TRAILS AND SIDEWALK MASTER PLAN

Phase 3A What We Heard Report

September 2020

MAP X: GAPS ASSESSMENT
NORTH

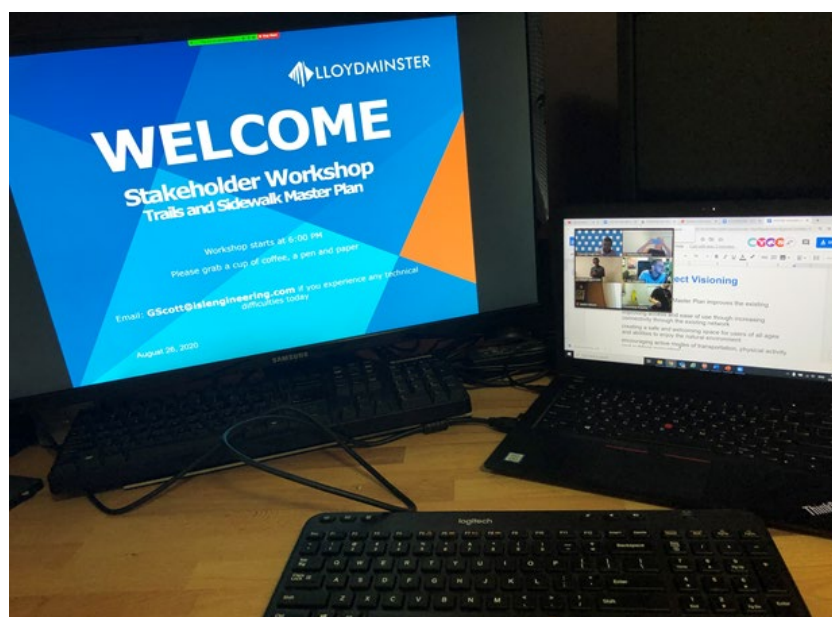
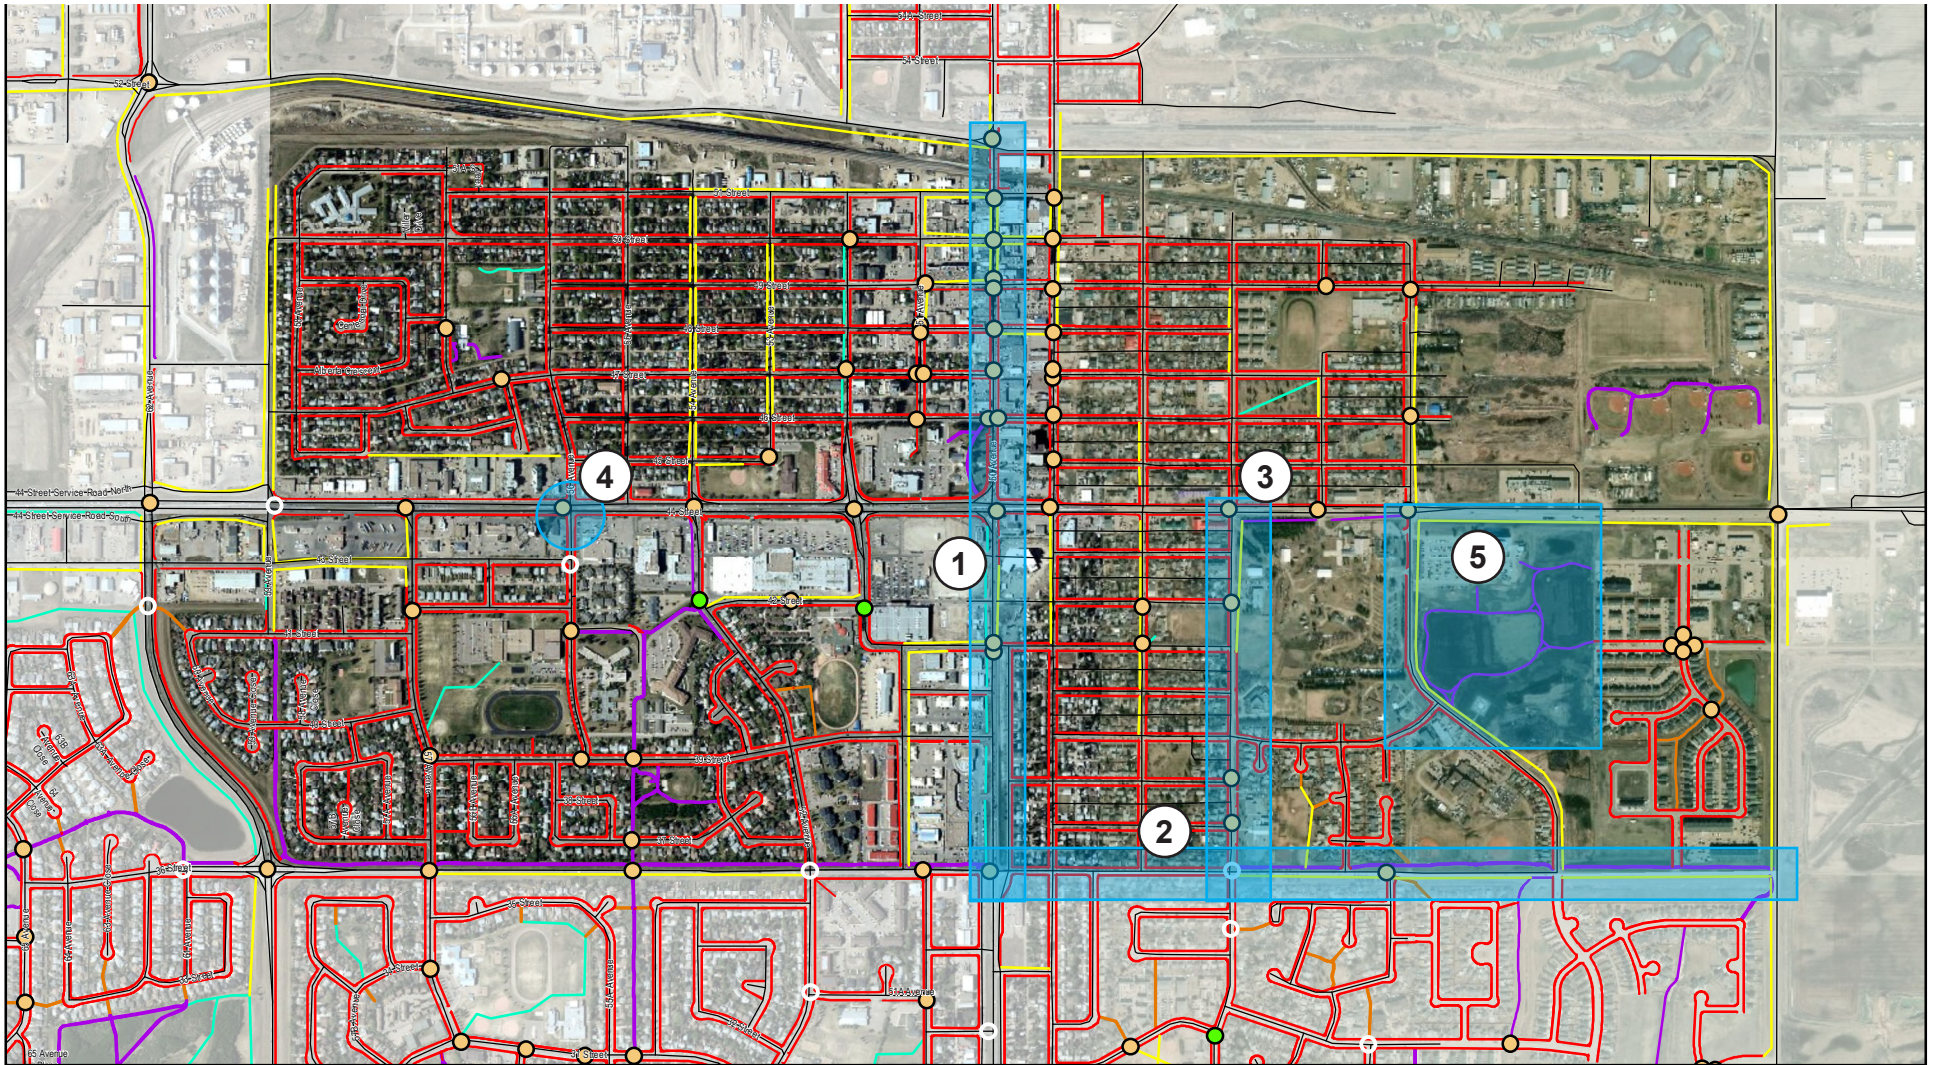
1. Identified missing crosswalk as shown on gaps map.
2. The trails here are currently well used by runners as it is cleared of snow regularly, and this provides an opportunity for a potential continuing exercise loop.
3. Cyclists do not like to cross Highway No. 16 as there are few safe crossing areas.
4. Some cyclists off-road in this area around the railroad track through the long grass.
5. Missing curb ramps and 52 Avenue needs more access for pedestrians, with parking on both sides it can hinder visibility and ease of use.
6. Traffic on 50 Street is very fast as the street is quite wide, there is an opportunity for a flashing light to increase safety. Suggestion for a flashing pedestrian light by the Pioneer Lodge or Outdoor Pool as they are well used and will continue to increase in use.
7. Long curb radius at 57 Avenue and 50 Street.

- Trails and sidewalk routes to the schools need to be a safe and well maintained
- Condition and future design of the sidewalks needs to be at the highest possible standard
- There needs to be better access and awareness of access to the northern industrial park for non-vehicle traffic, particularly as residents trying to get to 59 Avenue from Highway 16, there is an increase of commuter traffic along this route
- Creating shorter crossing distances for pedestrians throughout is important

- Need to consider trails within the Northeast Area Structure Plan
- Need to connect to Neale Lake on the northeast

MAP X: GAPS ASSESSMENT
CENTRAL

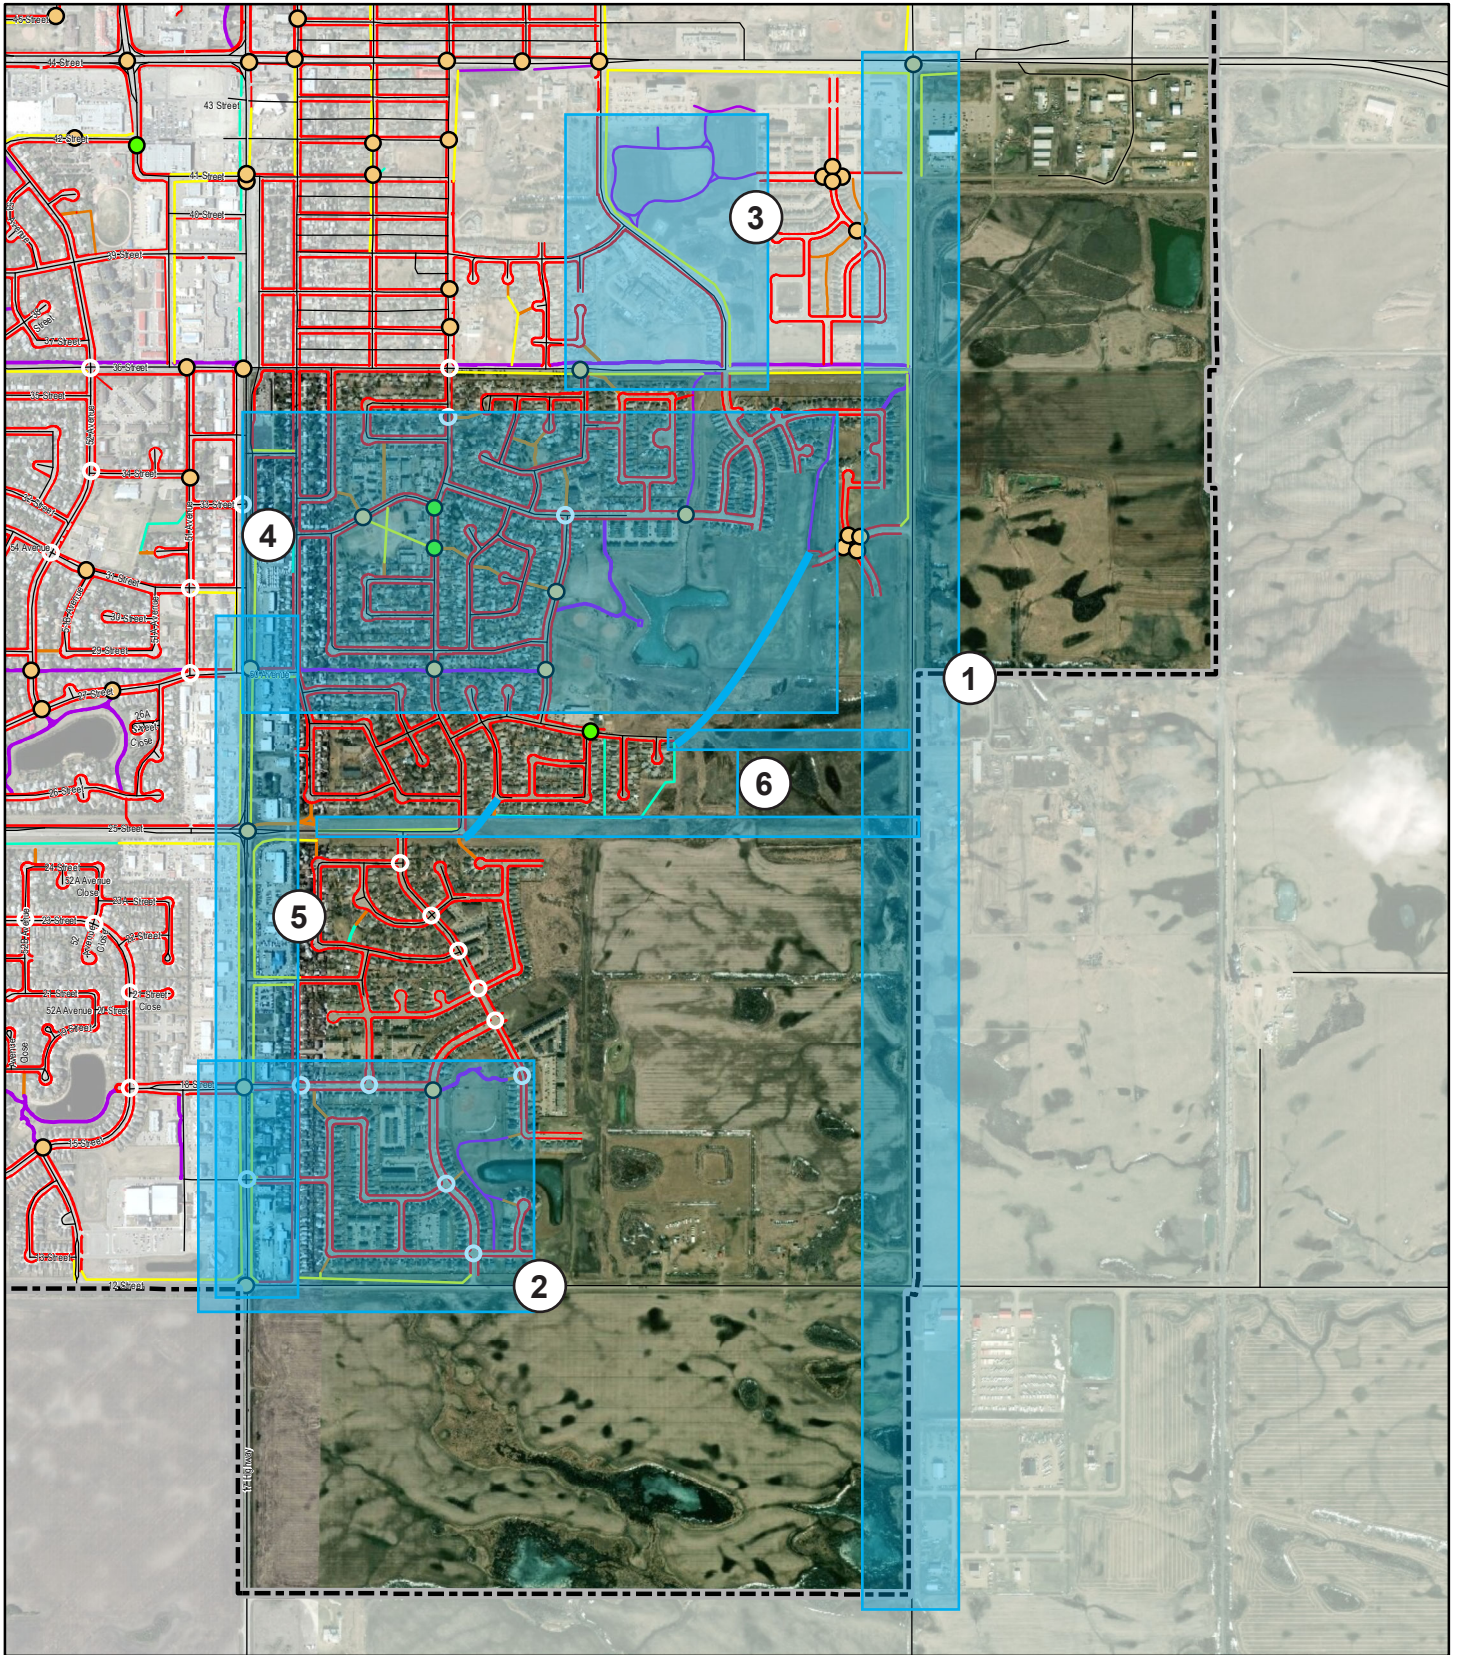
1. High amount of foot traffic, particularly around 36 Street. The crosswalk at 41 Street is lacking lighting and is one of the only spots to cross Highway 17. More pedestrian consideration to cross Highway 17 is desired

2. This road is currently very narrow for cyclists and runners with poor visibility, there is an opportunity for a trail (3m). Intersection at Highway 17 and 36 Street is used frequently by people going to the Co-op and the crossing time is too fast. Desire for more traffic calming and pedestrian-friendly changes, like curb extensions

3. Potential for a trail connection on the east side of 47 Avenue to the Dog Park and Cultural and Science Centre, not just sidewalk. There is a lot to see along 47 Avenue

4. Traffic light at 56 Avenue (Weirs Veterinarian Clinic) pedestrian light/signal is appreciated and is perceived as the safest crossing on the highway

5. Opportunity to connect Jaycee park to south Highway 16 trail

- The current connections from central to south are good, but maintenance is important for future use. Upkeep and maintenance of trees need to be a priority to keep the trails and sidewalks clear for users and maintain safe visibility. Maintenance and quality of the sidewalks on the Saskatchewan side is poor.

- The quality of sidewalk is poor or too narrow, so runners and cyclists are forced to use the road.
- Highway 16 is not overly used by runners due to the high traffic volumes, quantity of traffic lights, and requirement to cross.

- There is a lack of a connected trail system in the central area as compared to the south.
- Downtown is not very pedestrian/multiuse friendly; downtown is heavily under utilized due to lack of infrastructure; new developments on the major corridors should consider pedestrians and multi-use access and ease of use.

- Safety means wider trails and sidewalks for runners, cyclists and pedestrians, crossings that prioritize pedestrians, and uninterrupted loops for training purposes. Preference for more shared-use or multi-use paths.

- Opportunity for innovative designed crossing to increase safety called a *cyclops junction*.

MAP X: GAPS ASSESSMENT
SOUTHEAST

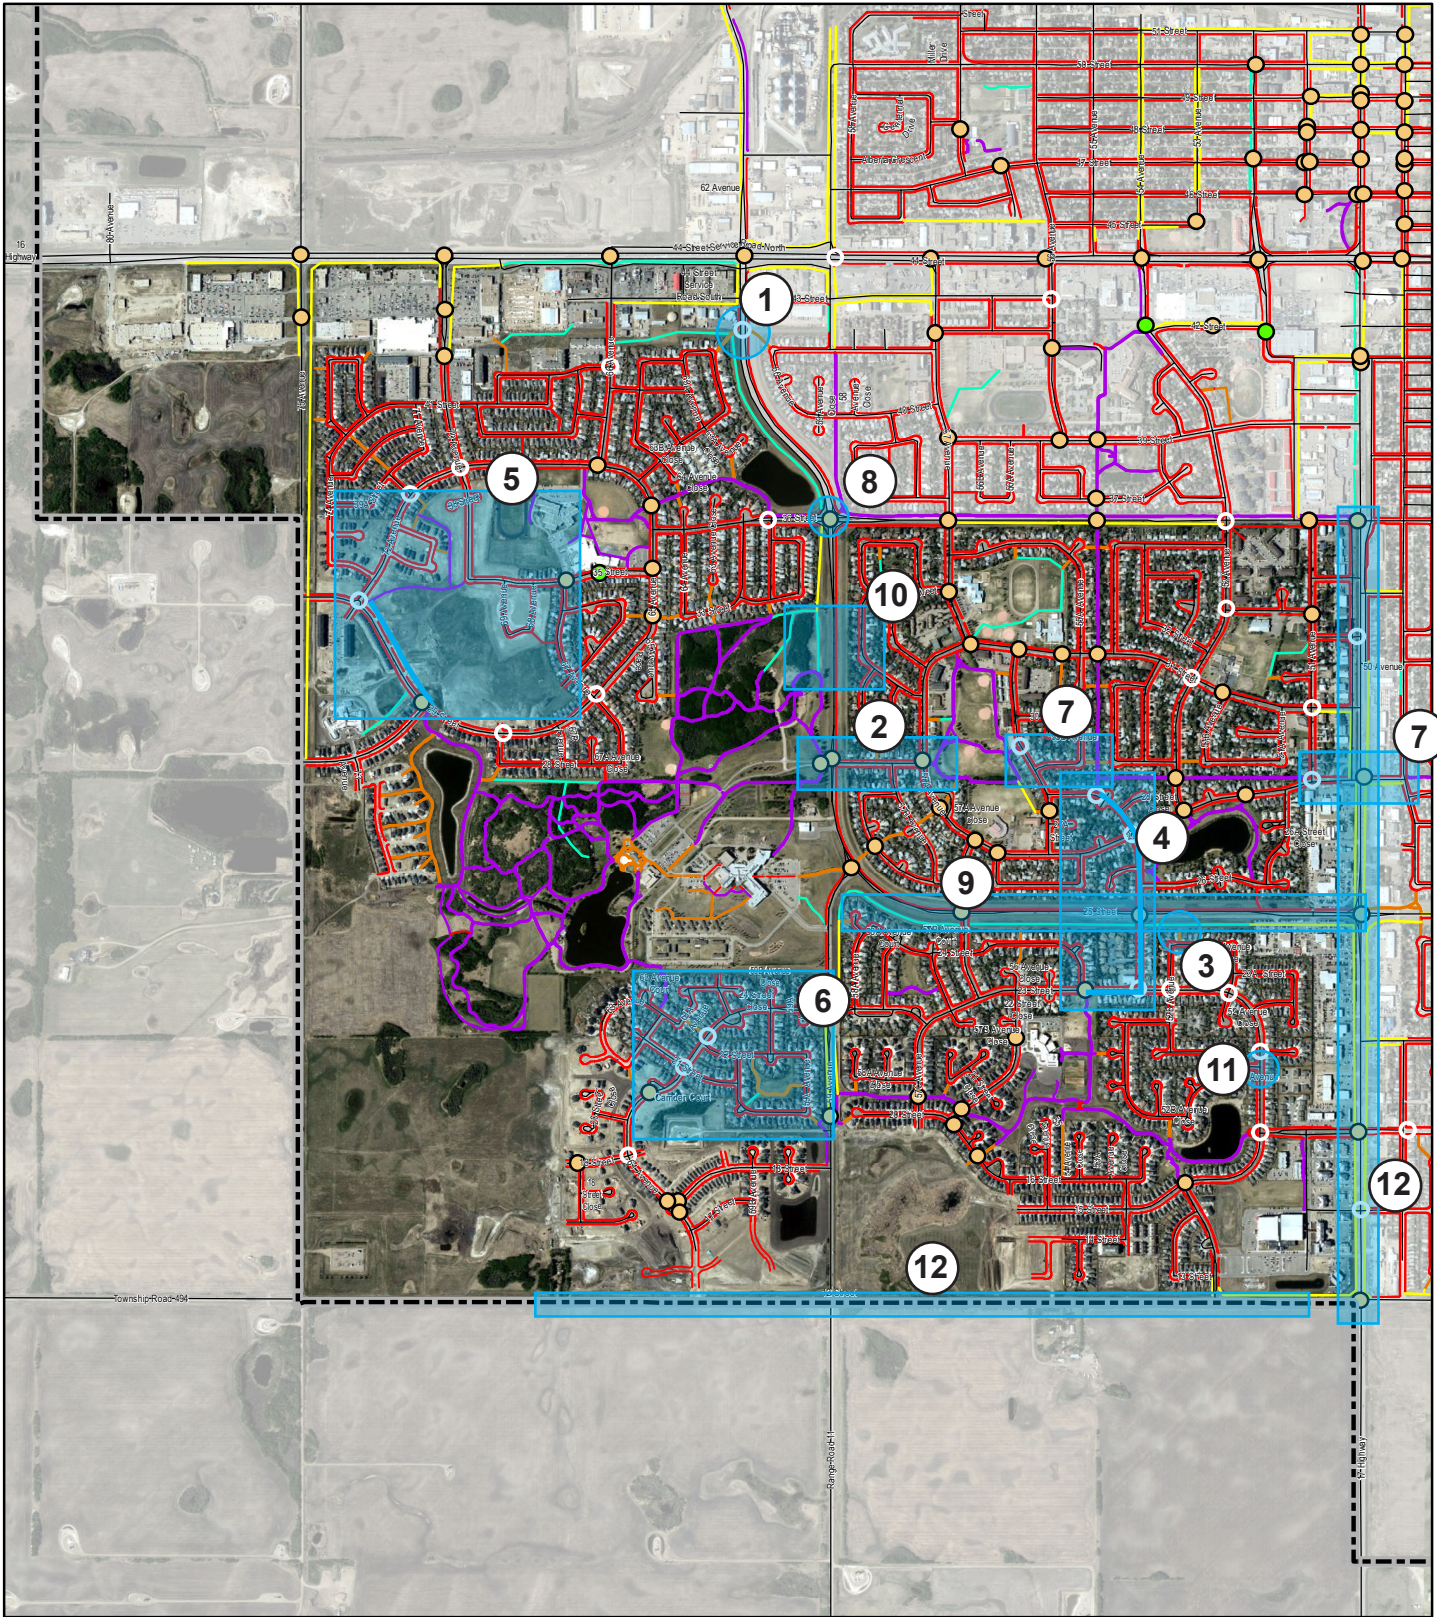
1. Opportunity on 40 Avenue as the east side of the city is developed to expand the trail system to be more connected and integrated with the residential area, as well with Jaycee park, down to the trails north of 12 Street
2. There needs to be more ways for non-car users to access the Servus Sports Centre
3. Opportunity to connect the trail systems in JC park to the existing east west trail on 25 Street
4. Running group crosses at 25 Street, and there needs to be a connection to 25 Street to the rest of the system in the neighbourhood, with connections needed throughout. Suggestion for one as indicated on the map.
5. It is very car focused around the car dealership and fast food area. There are many students who are employed who may not have access to a vehicle and rely on active mode infrastructure in the absence of a transit system.
6. Opportunity to connect east / west.

- Desire to expand and connect trail systems to create a longer uninterrupted network of connected systems.
- There is a potential and interest for the City to host events such as a marathon, as there is a strong community of active people, but the infrastructure needs to support it and be better connected to allow for uninterrupted routes.
- Idea for decorative stamps to aid in wayfinding, as signage often gets vandalized so decorative stamps would be a solution that can combat vandalism.
- Desire to see the future active transportation plans for the entire network.
